**CITY OF CRYSTAL
MINNESOTA**

RESOLUTION NO. 2016-39

**RESOLUTION REGARDING THE
METRO BLUE LINE EXTENSION**

RCSC Form and Responses

Current Pedestrian Bridge Design

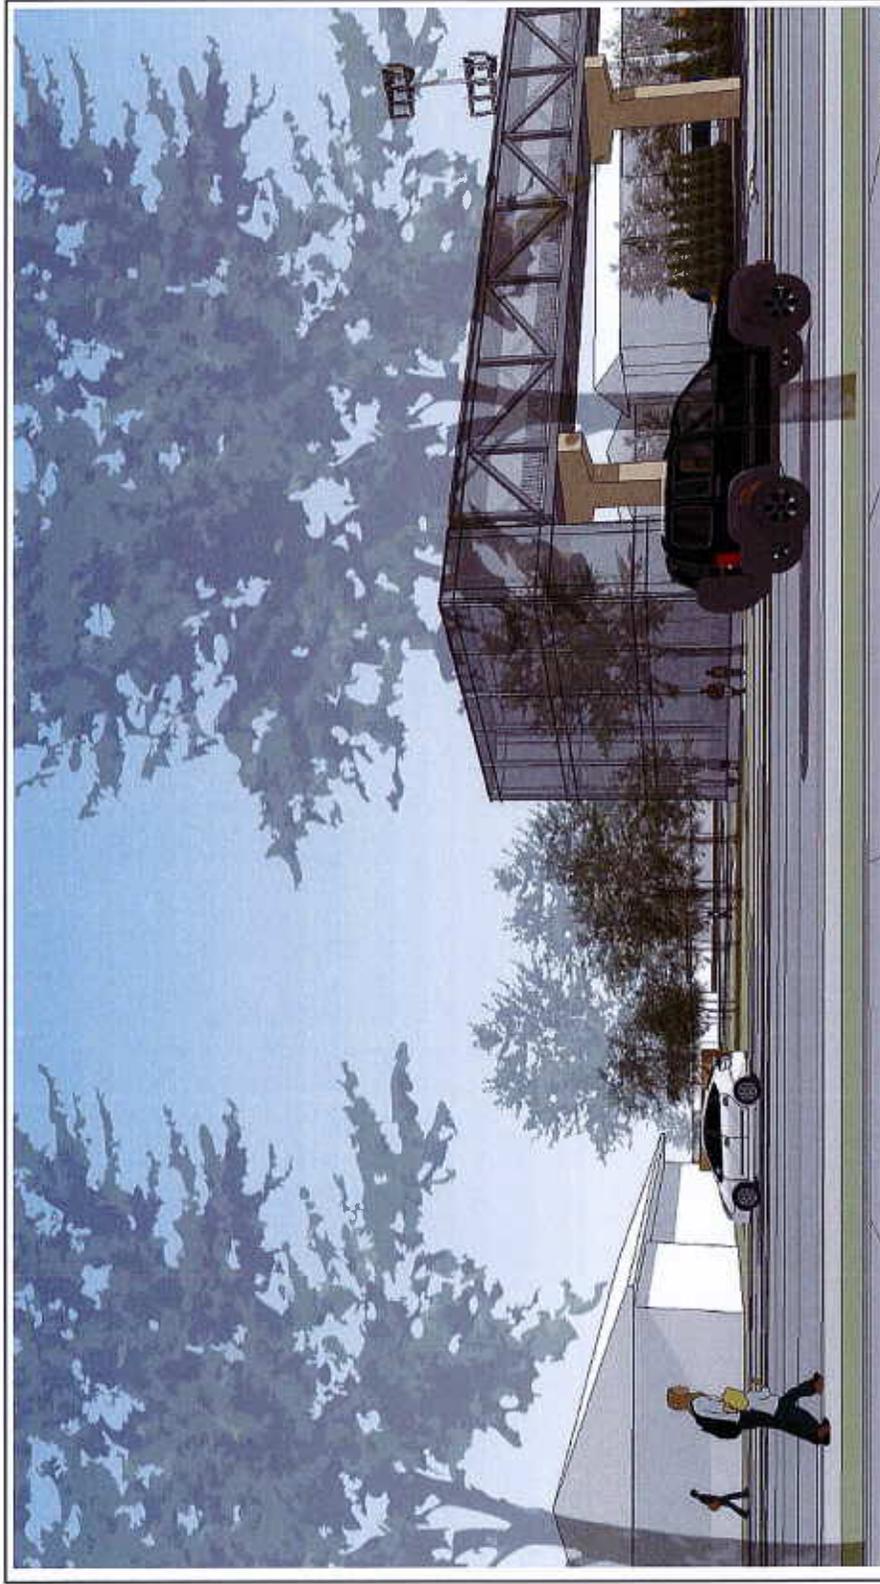
1. Consistent with the direction given by the Corridor Management Committee on February 11, 2016, a pedestrian bridge over Bottineau Boulevard (CSAH 81) on the south side of Bass Lake Road (CSAH 10) must be added to the Project scope and budget for the following reasons:
 - (a) CSAH 81 is a six lane, high volume, high speed roadway that is a real barrier for pedestrian access to the proposed Bass Lake Road station;
 - (b) This barrier is especially acute for youth, seniors and people who otherwise already face enough challenges just getting around. It is these very people who have the most to gain from the high frequency transit service the Blue Line Extension would bring to the City;
 - (c) For those who are able to drive, it is unreasonable to expect them to leave their cars at home if the Project does not provide a safe way for them to walk to the station;

- (d) With elevators on both sides of the pedestrian bridge, the crossing time would only be 44% longer than at grade, which is a small enough time differential that it will provide a useful alternative to crossing at grade; and

- (e) The proposed Bass Lake Road station is anticipated to primarily be a walk-up station which will dramatically increase the volume of pedestrian traffic at that intersection. Project staff has indicated that pedestrian crossings at the Bass Lake Road intersection are forecast to increase by a factor of four after the station opens.

2. Because the pedestrian bridge is an essential component for the success of the Bass Lake Road station, the construction, ownership and maintenance of the pedestrian bridge must be the responsibility of Metro Transit, not the City. The City will continue to work with Project staff to ensure an aesthetically acceptable design of the pedestrian bridge, the latest iteration of which is attached hereto as Exhibit A.

Becker Park Trail Connection Temporary Construction Area

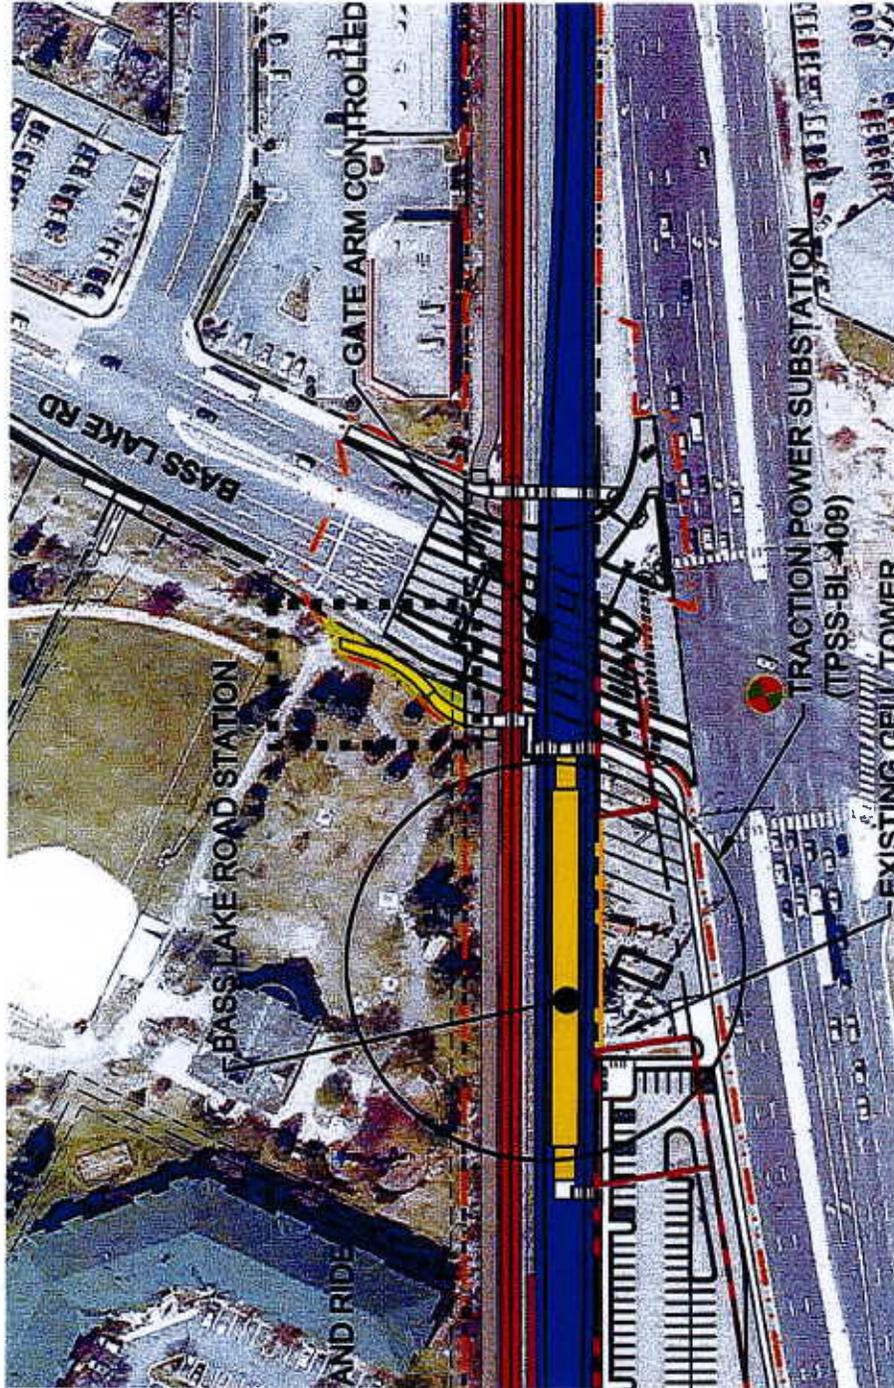
5. In order to accommodate the connection of the existing Becker Park trail system to the sidewalk and rail crossing being constructed as part of the Project, during construction approximately one-tenth of an acre in the northeast corner of Becker Park will be disturbed by the Project as shown in Exhibit B. A temporary construction easement will be needed and after construction the Project shall restore the disturbed area to a condition that is as good or better than its current condition. Pursuant to federal environmental rules, the Final Environmental Impact Statement must include documentation of the need for and impact of this temporary construction easement. The City Council authorizes the City Manager to provide said documentation to the Project as needed for the Final Environmental Impact Statement.
